PRELIMINARY/FINAL DRAINAGE REPORT

JUDGE ORR ROAD RV PARK & STORAGE DEVELOPMENT

**ADP Project No.160301
May 1, 2019**

PCD Project #PPR-16-040

PROJECT: JUDGES CREEK RD, EL PASO
WEST CULVERT - RANGE FLOWERS

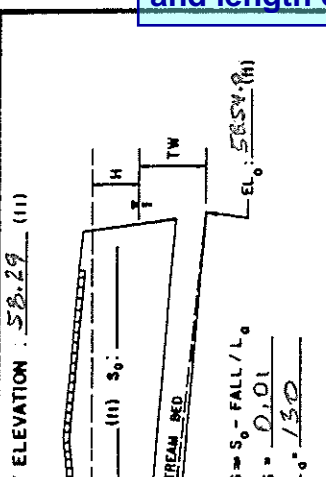
Unresolved. Provide the outlet velocity. If it exceeds the allowable for native grass then erosion protection is required.
 Unresolved. The revised GEC now shows erosion protection, however no riprap calculation is included with the drainage report to indicate adequate size and length of protection.

COMMENTS / DISCUSSION:
 Update this worksheet. The GEC plans and the rational calculation noted (3) 38"x24" RCEP.

PROJECT : Judas Cree Rd RV Park
EAST Culvert - Fire Access

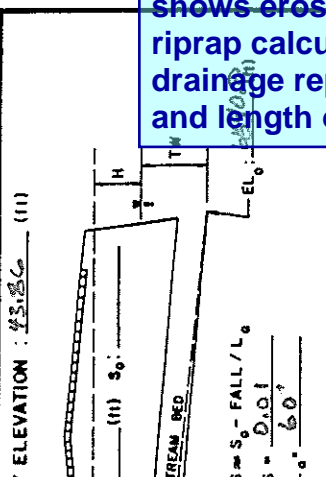
Unresolved. Provide the outlet velocity. If it exceeds the allowable for native grass then erosion protection is required.
 Unresolved. The revised GEC now shows erosion protection, however no riprap calculation is included with the drainage report to indicate adequate size and length of protection.

COMMENTS / DISCUSSION:
 Update this worksheet. The GEC plans and the rational calculation noted (3) 38"x24" ROE
 CULVERT BARREL SELECTED:
 SIZE: _____
 SHAPE: _____
 MATERIAL: _____
 ENTRANCE: _____

FIGURE 5-7. RIPRAP EROSION PROTECTION AT CIRCULAR CONDUIT OUTLET.

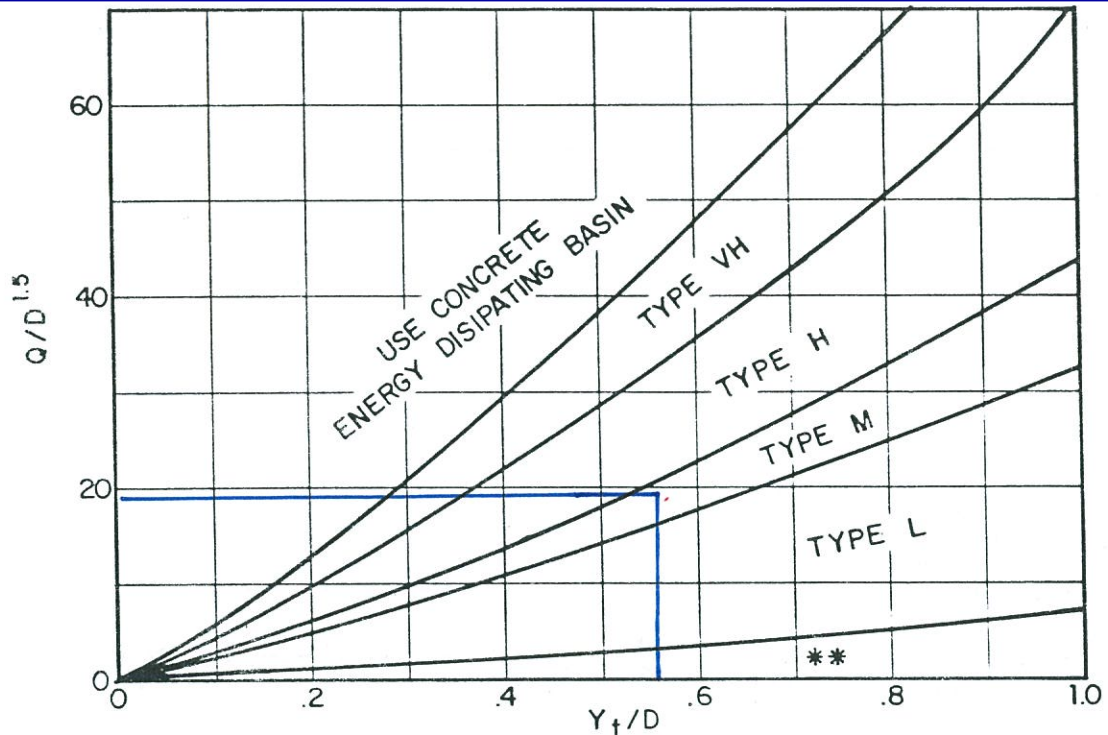
Outlet protection calculation is incomplete.

Show the variables used.

Additionally, this only provides the riprap sizing, but not the required length for the protection. Use the UD-Culvert worksheet. The length of outlet protection appears to be inadequate.

Unresolved. Variables used for Q , D , Y_t , D is not provided. Update calculation. This chart is still the same chart from the previous design when the future pond drained into Pond 2 (Pond-in-a-series). Values are unlikely to remain the same. The current drainage has since been revised to discharge this offsite flow separate from Pond 2 at the same spillway location. Riprap sizing must account for the combined flow.

DETENTION BASIN STAGE-STORAGE TABLE BUILDER

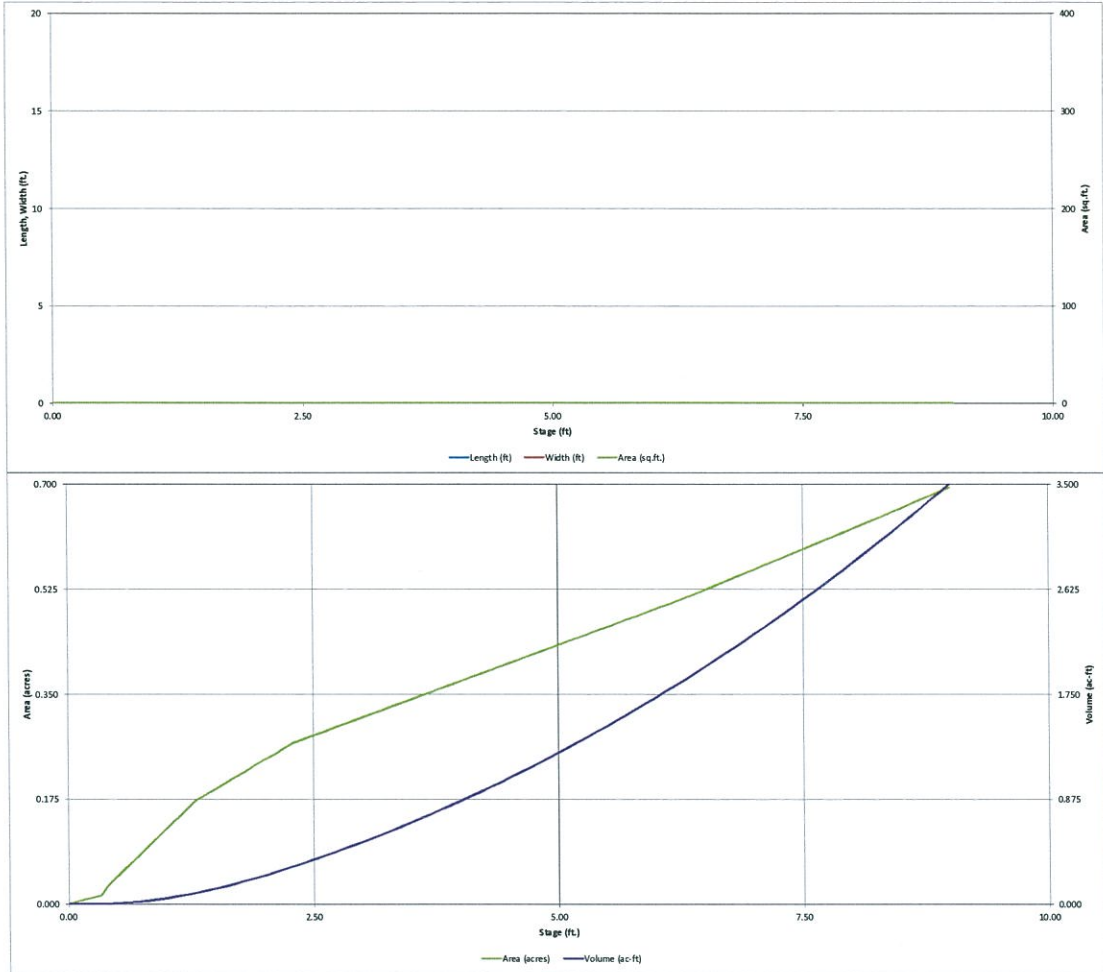
Update the Basin ID to match the Detention Basin Stage-Storage Table

Builder worksheet

Unresolved. See title in pg 29 of 43

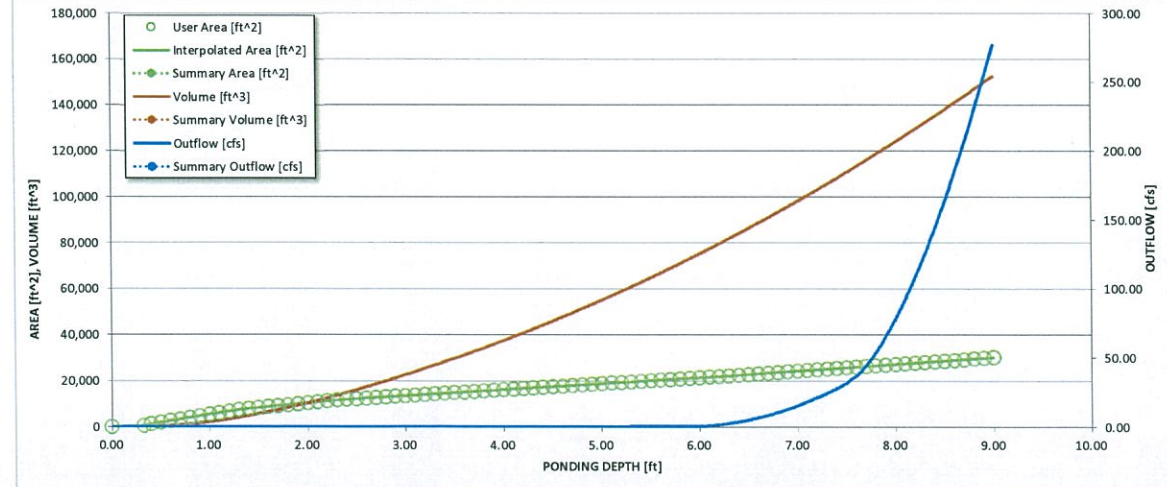
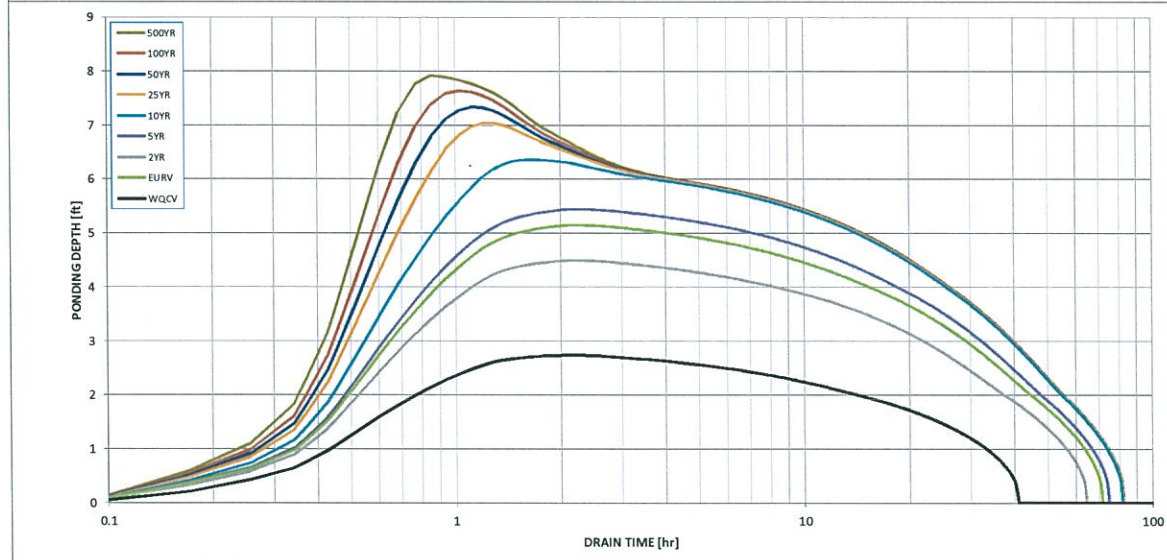
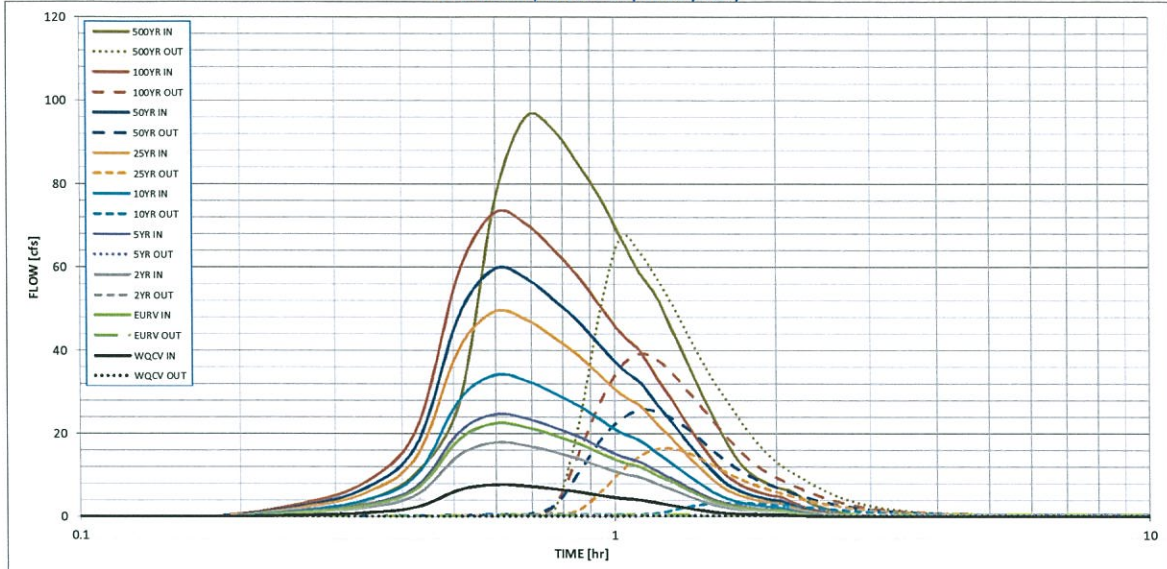
1. 1.5yr must be at or below historic rate. Resolved.

2. Revise design so 50 yr and 100yr goes through the outlet pipe. unresolved.
